RE: **PETITION NO. 1442 - SR Litchfield, LLC Declaratory Ruling**, pursuant to Connecticut General Statutes §4-176 and §16-50k, for the construction, maintenance and operation of a 19.8-megawatt AC solar photovoltaic electric generating facility on 6 contiguous parcels located both east and west of Wilson Road south of the intersection with Litchfield Town Farm Road in Litchfield, Connecticut, and both east and west of Rossi Road, south of the intersection with Highland Avenue in Torrington, Connecticut, and associated electrical interconnection. **Partial Development & Management Plan III Revision.**

Pursuant to Regulations of Connecticut State Agencies (RCSA) §16-50j-62(b), your request to modify Wet Swale No. 11 by relocating the emergency outfall structure to discharge to the east rather than the south is hereby approved.

### **Swale 11 Minor Modification**

C402

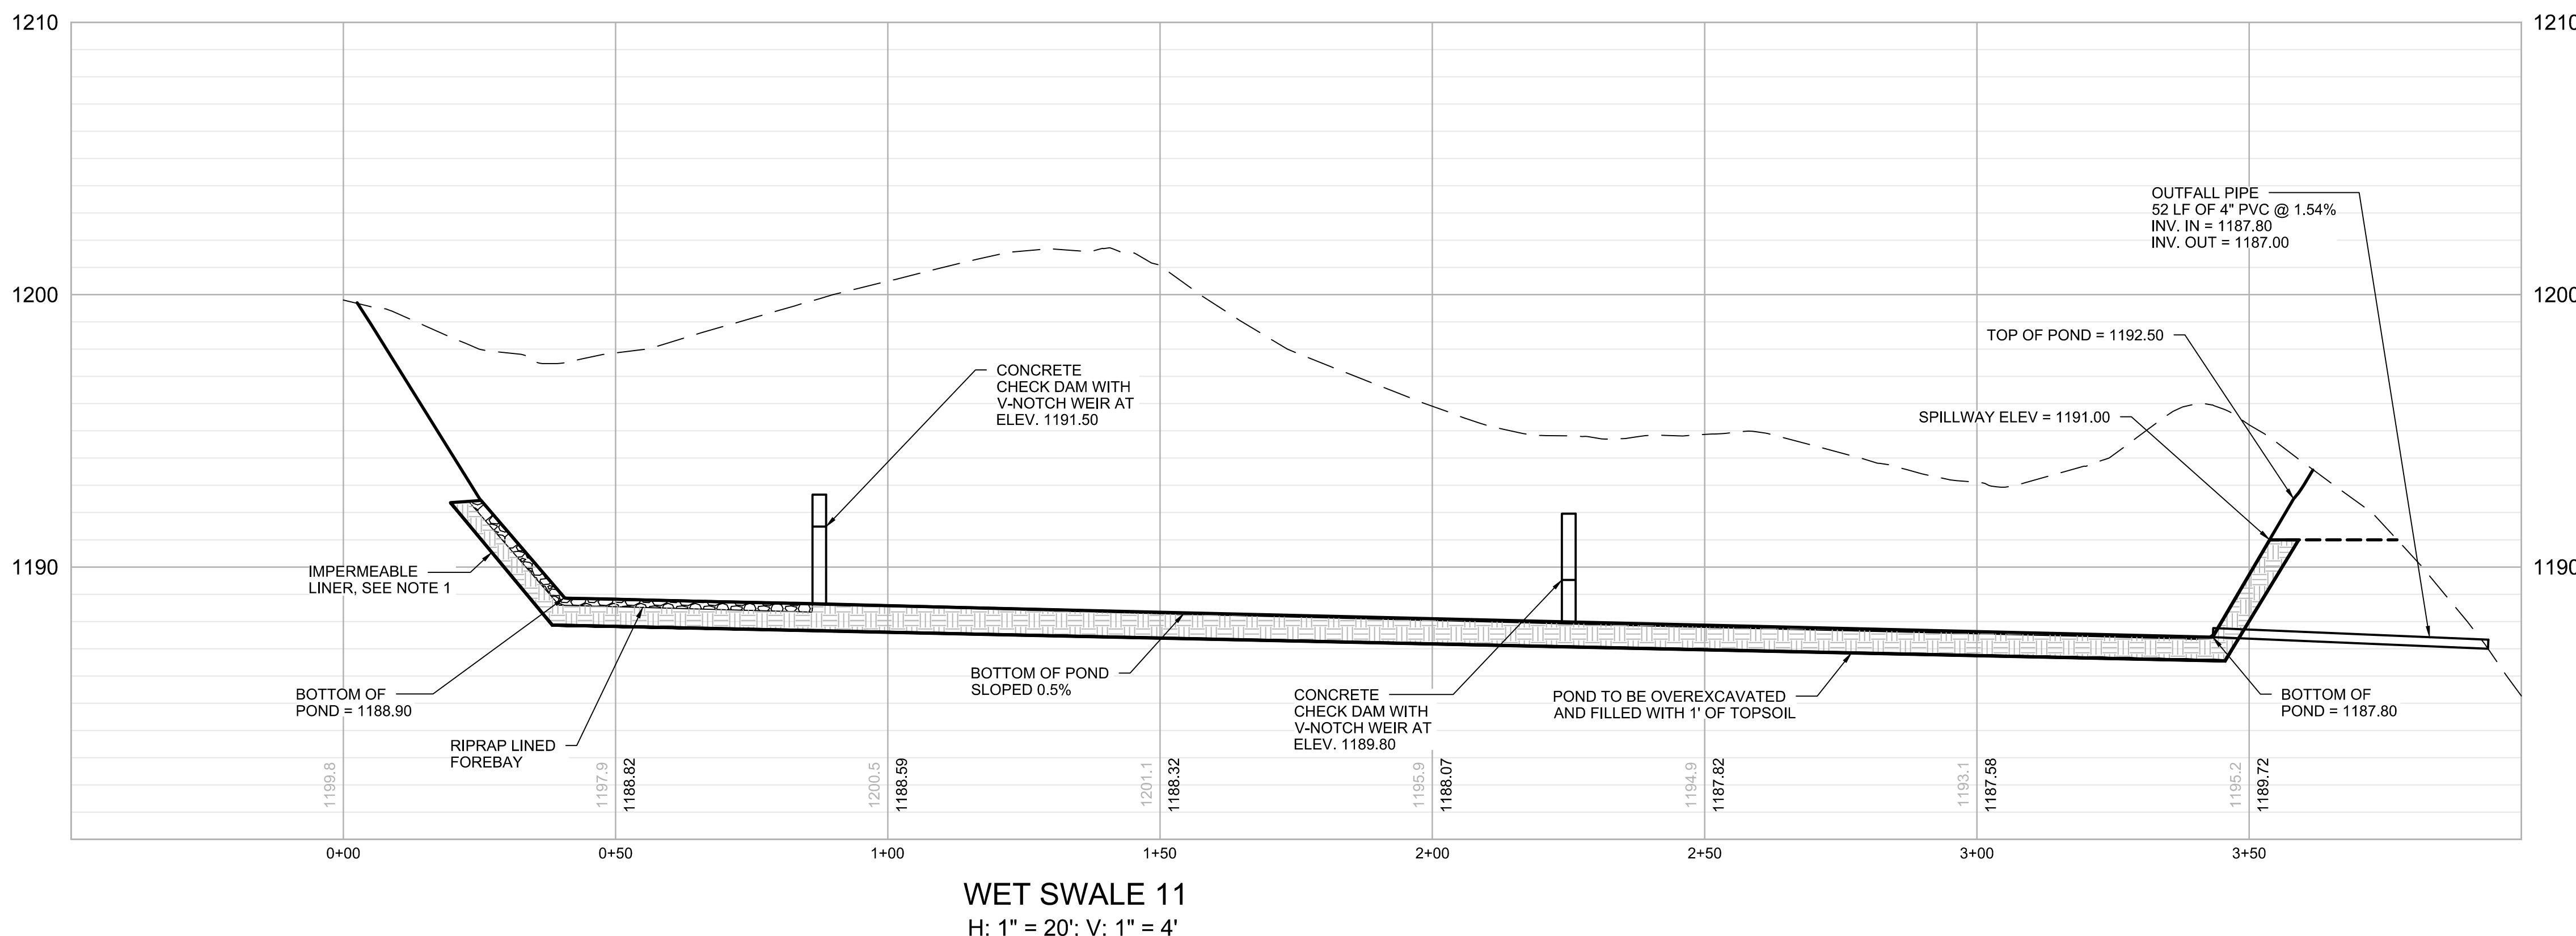
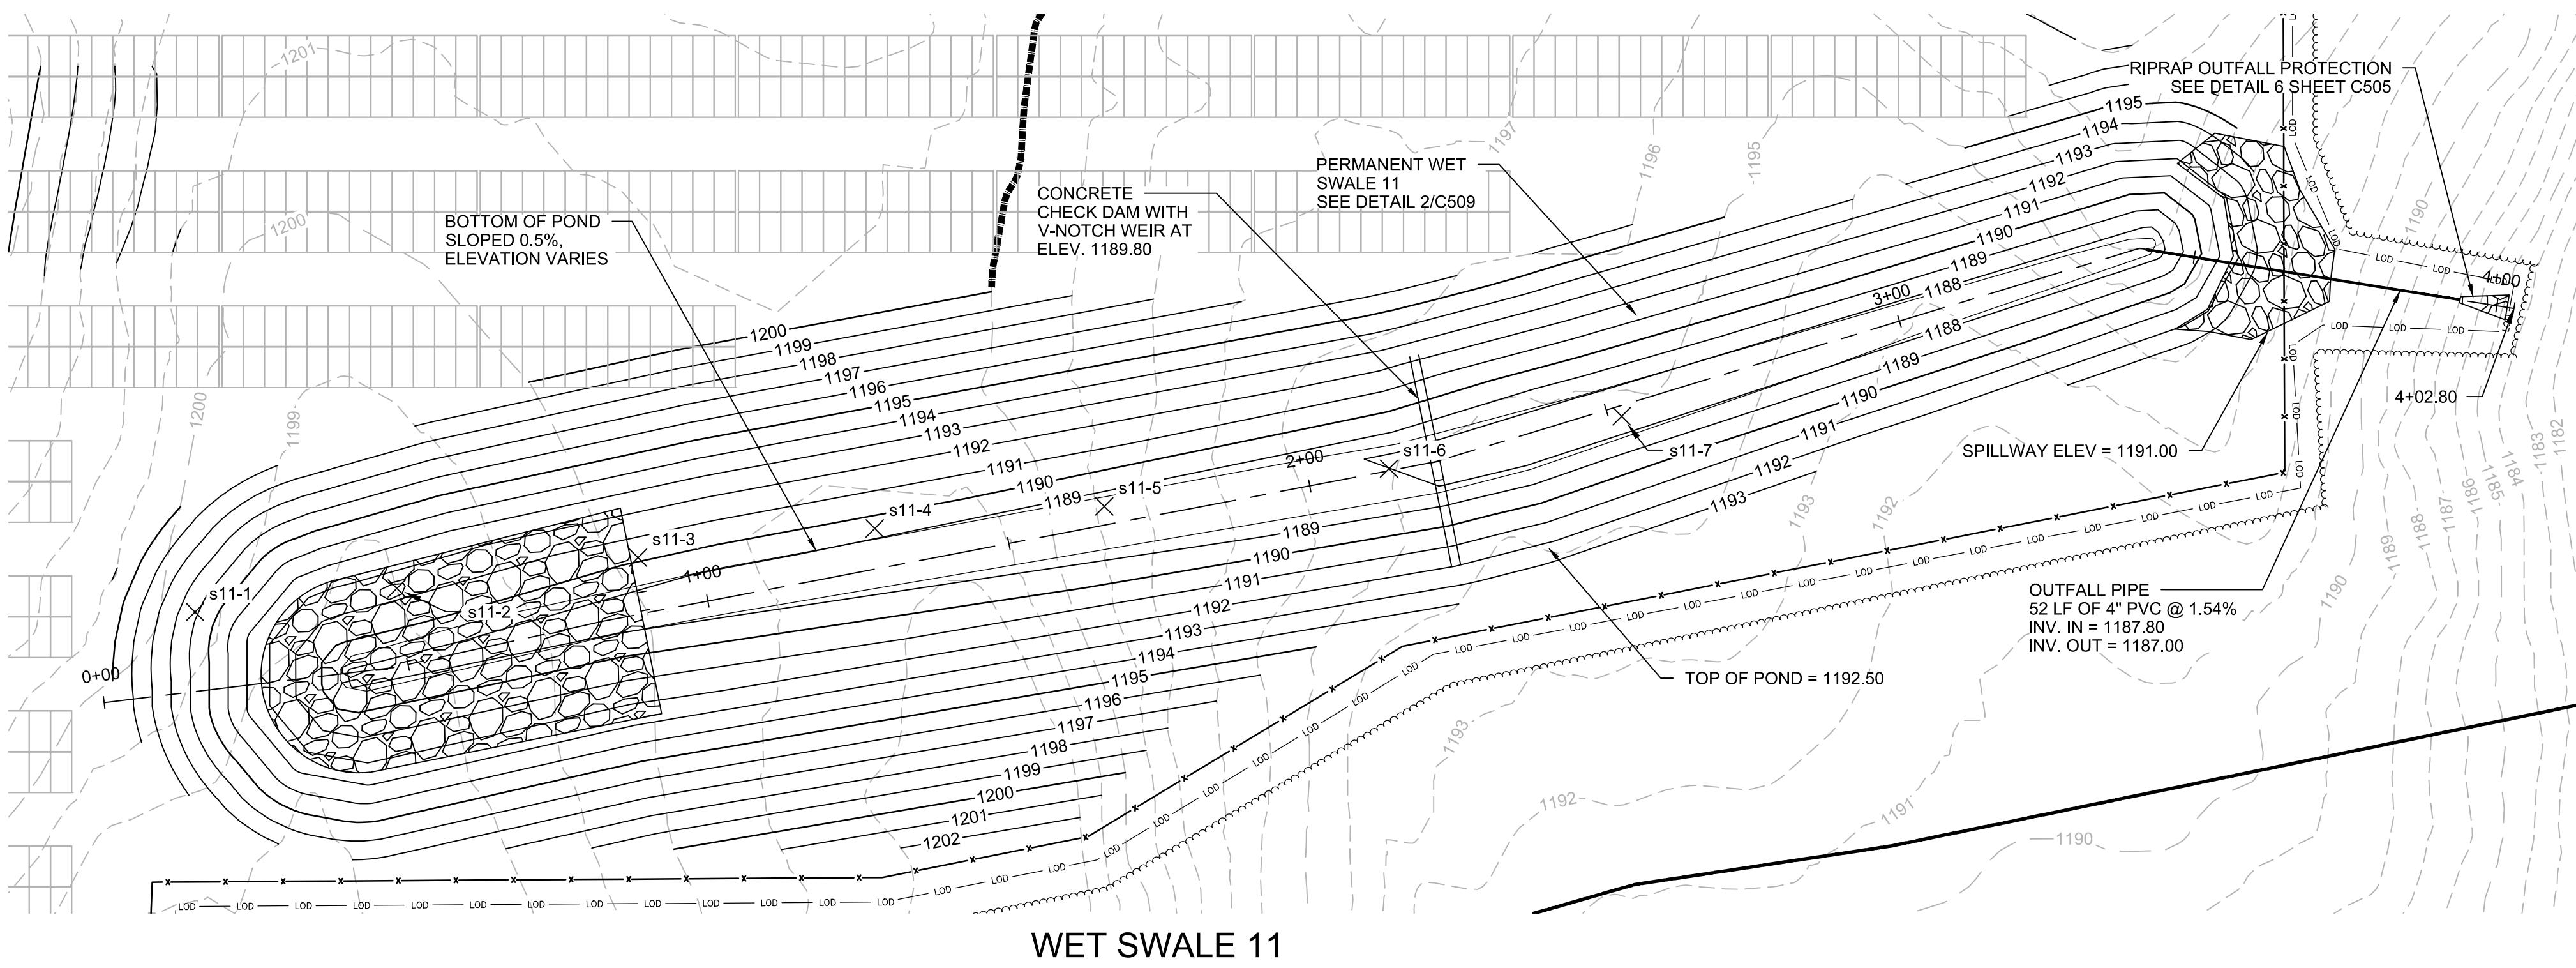
In accordance with RCSA § 16-50j-62(b), SR Litchfield, LLC (“SRL”) hereby notifies the Connecticut Siting Council’s (“Council”) of a minor modification to the approved stormwater design. At the request of Ron Viola, a neighboring property owner, SRL has redesigned Swale 11 to modify the location of the emergency spillway. This modification requires a minor expansion of the limits of disturbance to the east of Swale 11 by 456 square feet (0.01 acre). The Connecticut Department of Energy and Environmental Protection (DEEP) Stormwater Bureau has reviewed and accepted this minor modification to Swale 11 and has incorporated the same into the existing Stormwater General Permit.

15	REVISED SWALE 11	01/19/24
14	REVISED PER SITING COUNCIL	11/14/23
13	REVISION FOR CLARITY	09/26/23
12	RE-ISSUED FOR PERMIT	08/16/23
11	RE-ISSUED FOR PERMIT	06/09/23
REV. NO.	DESCRIPTION	DATE
